From: [REDACTED]
Sent: 24 July 2026 11:46
To: Planning
Subject: Planning application DC/26/0946
Attachments: Cricket club planning.pptx
Categories: Comments Received

Steypning Cricket Club

Comments on DC/26/0946

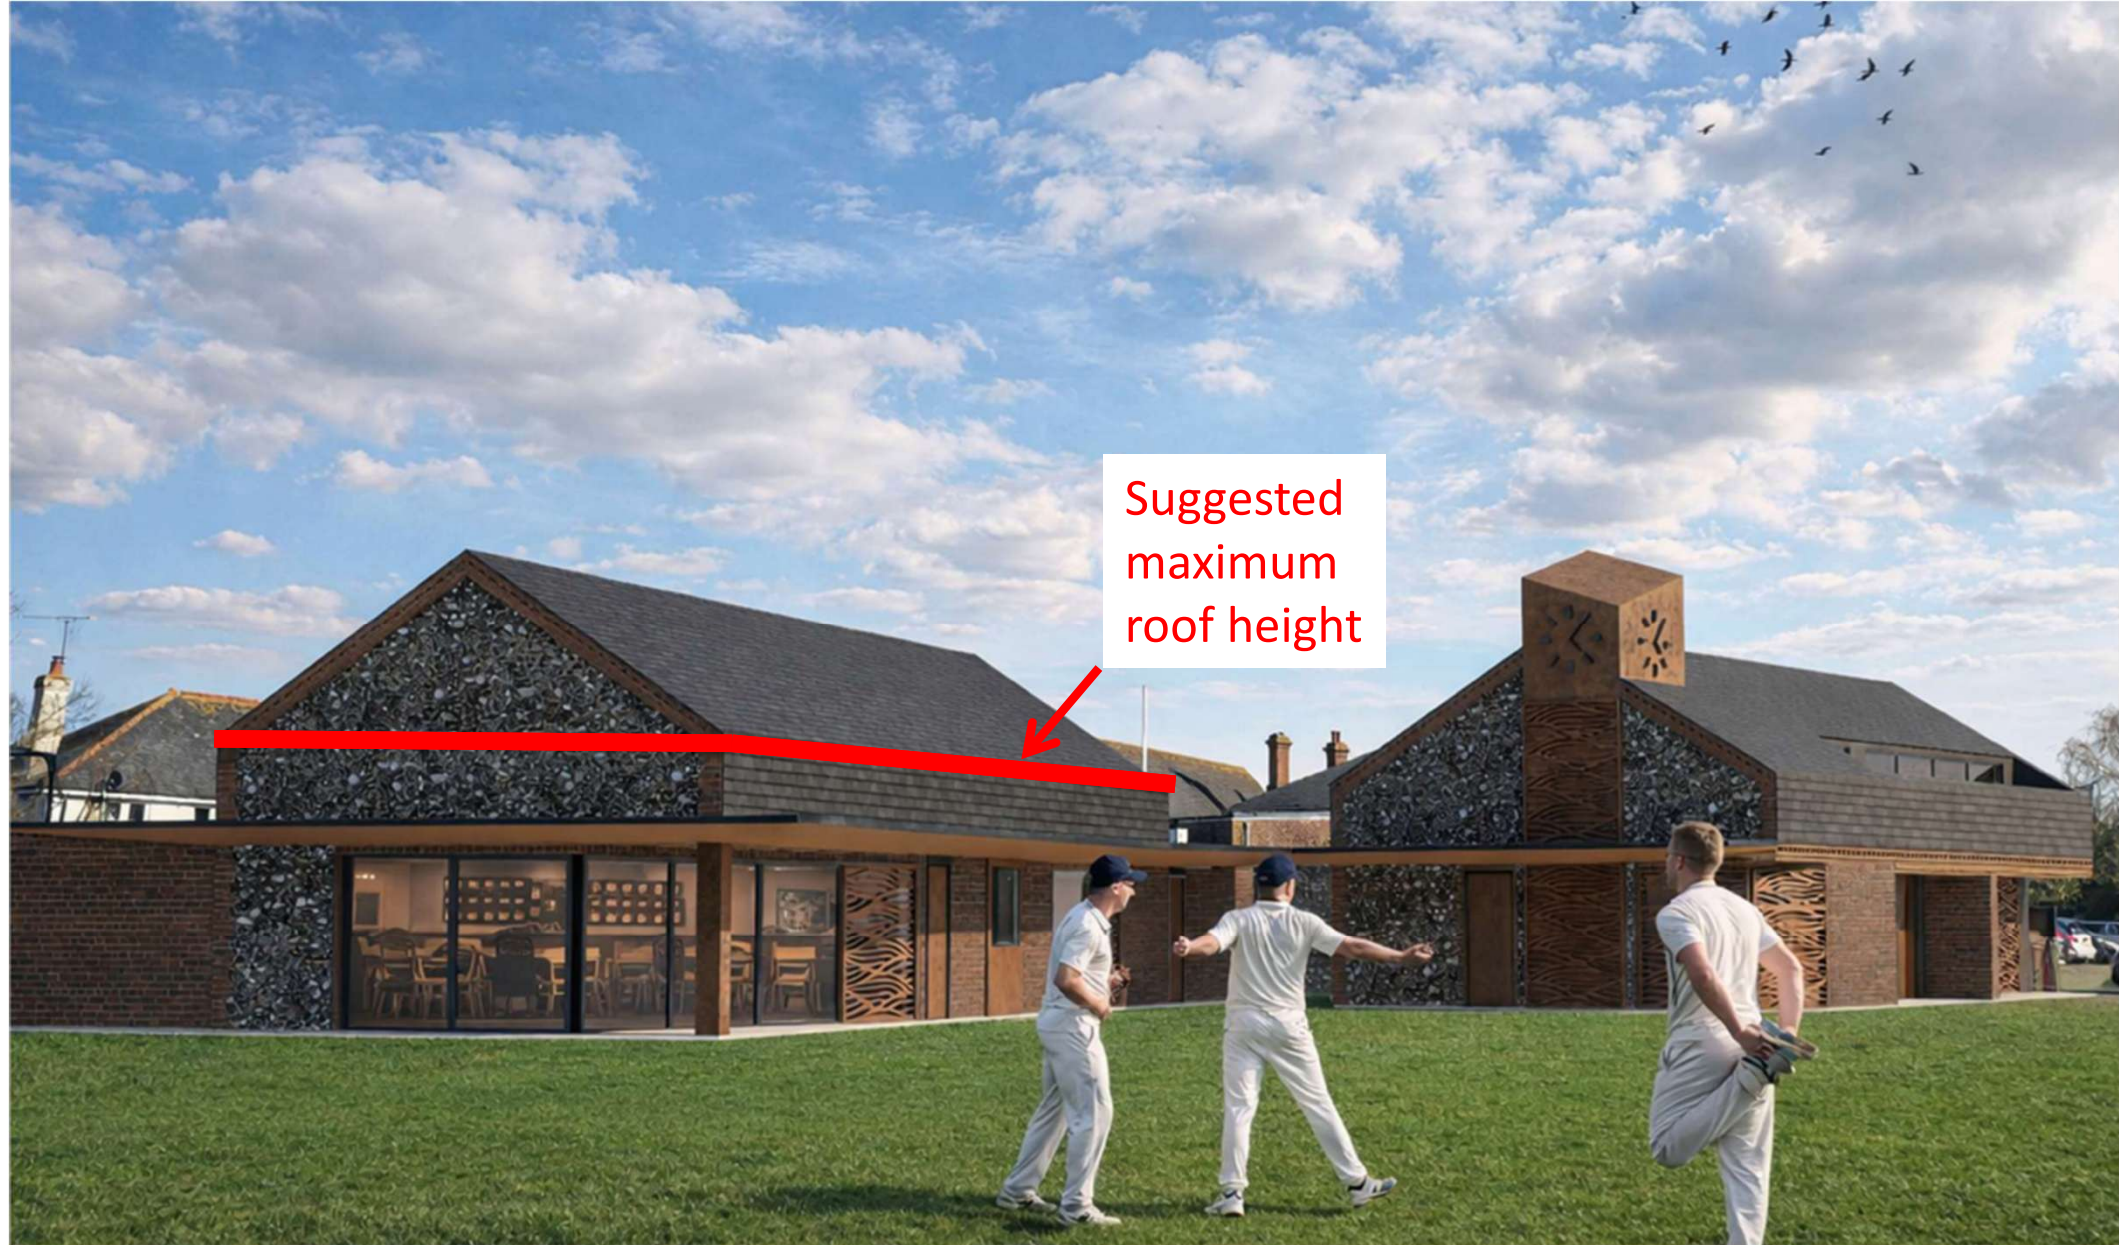
1. The proposed gable roof over the bar area (see Supporting Design Document 12.03) is nearly twice the height of the current pavilion and produces a dark and unsympathetic visual barrier between the playing field and the interesting townscape / roof scape of Charlton Street behind. It also blocks glimpses of the Downs for pedestrians in Charlton Street (eg between 1 the Plough and 3 The Gardens). For the neighbours living behind, it creates a dark barrier between them and the Downs.

The adverse visual impact would be much reduced, and the forbidding character of the building would be lessened if the gable was removed from the pavilion building and replaced with another, slightly higher, flat roof.

Reducing the roof height of the Pavilion as suggested would:

- Greatly reduce the visual impact and loss of light for neighbouring properties
- Make the building less imposing and out of place when viewed from the playing field
- Be more in keeping with the function of the building as a sports pavilion
- Still provide architectural interest

Suggestion: We suggest the gable roof is removed and replaced by a flat roof, which could be slightly higher than the remainder of the flat roof to create architectural interest and some increase in internal height over the bar area. This would result in a less imposing, less dark and more friendly building with much less of a barrier between the town and the Downs. See the attached visual showing suggested line of the amended roof. (Sent by separate email)
